Re: 49 Stephen Road, Banksmeadow, NSW
Response Letter – Bayside Council

Further to your request we are pleased to provide our response to the civil items raised by Bayside Council in their Request for Advice letter dated 15 May 2026 (ref: SSD-2025/1) in relation to Development Application SSDA-65924461.

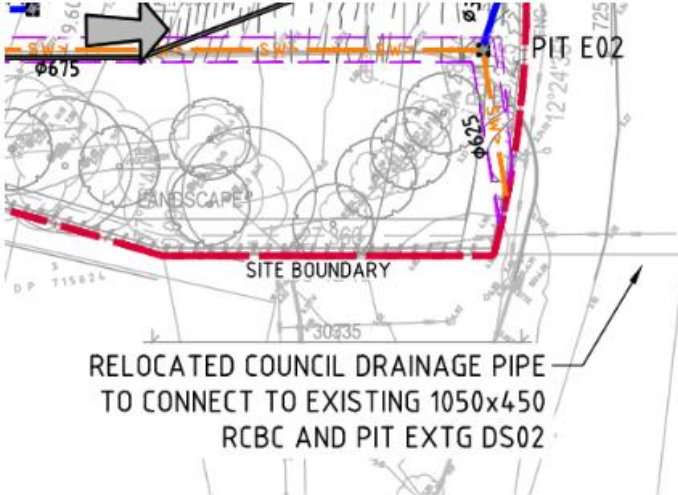
- b) The CCTV footage and reports shall be provided for the existing Council drainage pipe traversing the site and the stormwater pipes in Stephen Road and Coal Pier Road.

ESR to provide MNG Land Partners CCTV footage.

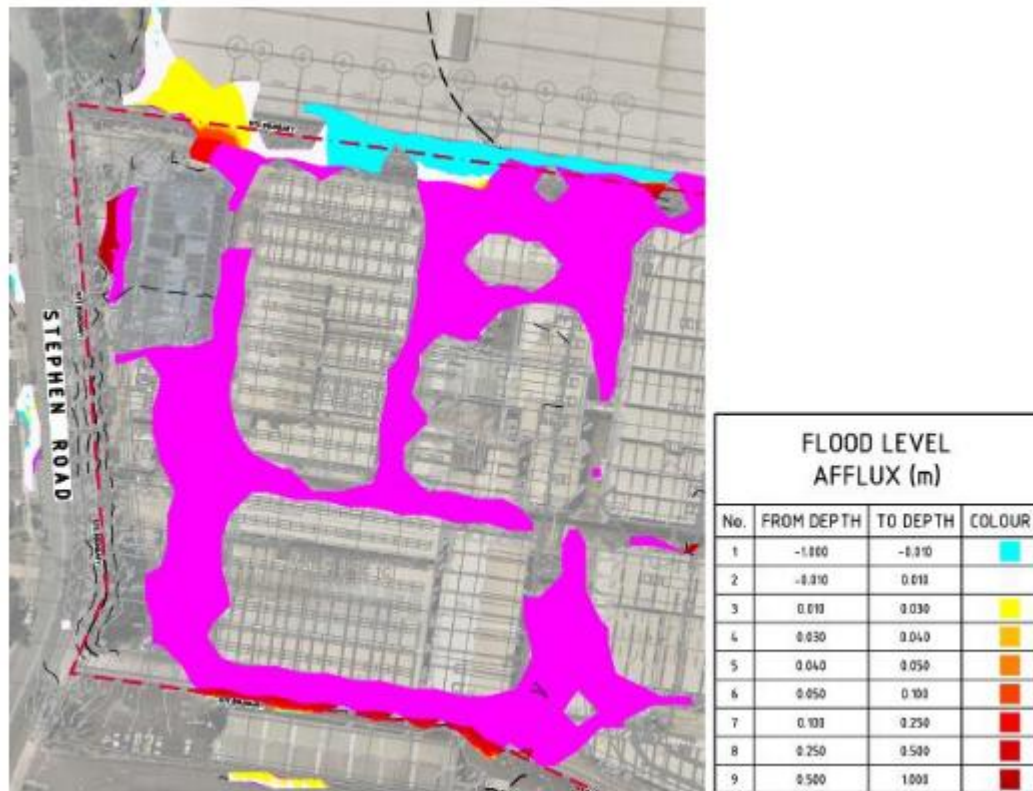
k)	Section 1 of the civil plans (drawing CO14950.01-SSDA460) contain the following errors:
a)	The storm filter chamber is shown to have a full height wall where a weir exists on the OSD tank plan. Another full height wall is shown next to the orifice wall where no such

wall exists on the OSD tank plan. These full height walls shall be replaced with weirs, and the weirs shall be clearly shown. <u>RESPONSE</u> Refer updated OSD plans SSDA460 and SSDA461.

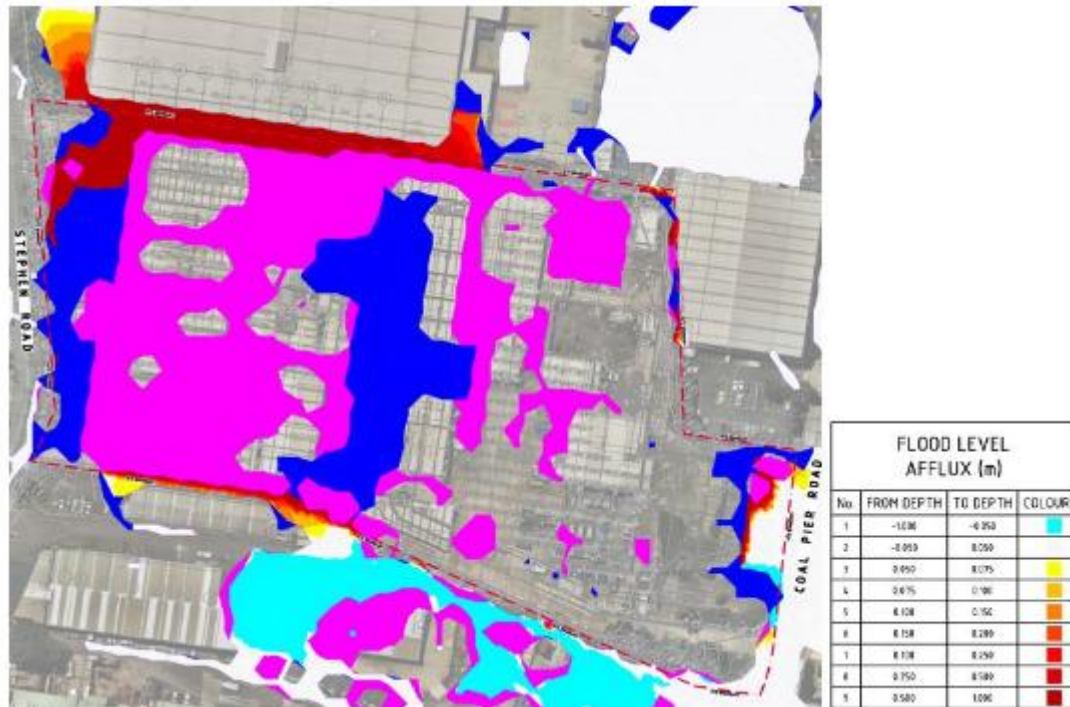
There is significant increase in flood afflux (changes to flood levels) shown to occur on neighbouring properties in the 1% AEP and PMF flood events which is unacceptable: • The increase in 1% AEP flood levels on neighbouring properties must be less than, or equal to, 10mm. The development proposes an increase in flood levels ranging from 10mm-30mm on neighbouring properties which far exceeds the maximum tolerance. This is not acceptable and results in an unacceptable impact on the floodplain. The development must be revised to reduce 1% AEP flood level increases on neighbouring properties to less than 10mm which shall be confirmed in amended flood modelling.

There are also significant changes to 1% AEP flood velocity on neighbouring properties that have not been demonstrated to be appropriate.

<u>RESPONSE</u> There is minor afflux observed at the site boundaries during the 1% AEP storm event however this is understood to be a modelling anomaly resulting from a trapped low point in the DTM surface that is not located over a drainage pit. There is afflux shown at the boundaries of the site as a result of meshing differences between the detailed survey and council's digital elevation model. The lack of neighbouring drainage data that would eliminate the flooding through the trapped low points adjacent to the buildings. The flood modelling has been based on available information which does not include local drainage networks of neighbouring properties. The detailed survey provides the location of a few neighbouring pits but not the full information which will make a substantial difference in the afflux shown. The Bayside West Floodplain Risk Management Floodplain Risk Management Study and Plan Part 1 notes that shallow depths below 150mm would typically be considered as drainage issues rather than flooding. The majority of the flooding shown would be below 150mm in the 1% AEP, especially so with if the full private drainage network of neighbouring properties were included. Further to our ongoing assessments and finalisation of the RtS response package, we provide the following discussion pertaining to the flood assessments completed for the development, and the comments from Council around those assessment. We reiterate our position that the site, other than the boundary fronting Coal Pier Road and minor overland flow from Stephen Road at the SW corner of the property, is flood free. The site is not influenced by major flow paths such as the Floodvale Drain, nor the Sprinvale Drain. The site is not affected by Botany Bay or oceanic mechanisms. This is noted to be accepted by CPHR as outlined further below. Council have reported in their Request for Advice letter dated 15 May 2026 Item 14 Floodplain Management that: <i>"The submitted flood modelling contains numerous errors and unacceptable flooding outcomes from the development which is not supported. Concerns remain with the entire design of the development and its lack of consideration to flooding impacts."</i> In response, we provide the following discussion items including extracts from the Council Flood Advice Certificate dated 19 September 2024 (Ref: FA-2024/211), obtained by Costin Roe Consulting, for the 1% AEP flood event and that from the modelling completed by our office. Councils flood advice mapping and letter indicates the following: 1. The majority of identified flooding across the site comprises shallow ponding with an H1 flood hazard classification (low hazard/no restrictions). 2. Most of the mapped flooding is categorised as flood fringe. 3. No areas within the site or surrounding land are identified as floodway. 4. Localised areas at Locations 4, 10 and 11 are identified as H3 hazard and flood storage areas. 5. Locations 4, 10 and 11 correspond to existing localised depressions associated with former first flush basins and chemical management basins related to the historical use of the site. These items, being dedicated water storage systems do not form flood affected areas, despite the modelling showing them as such.
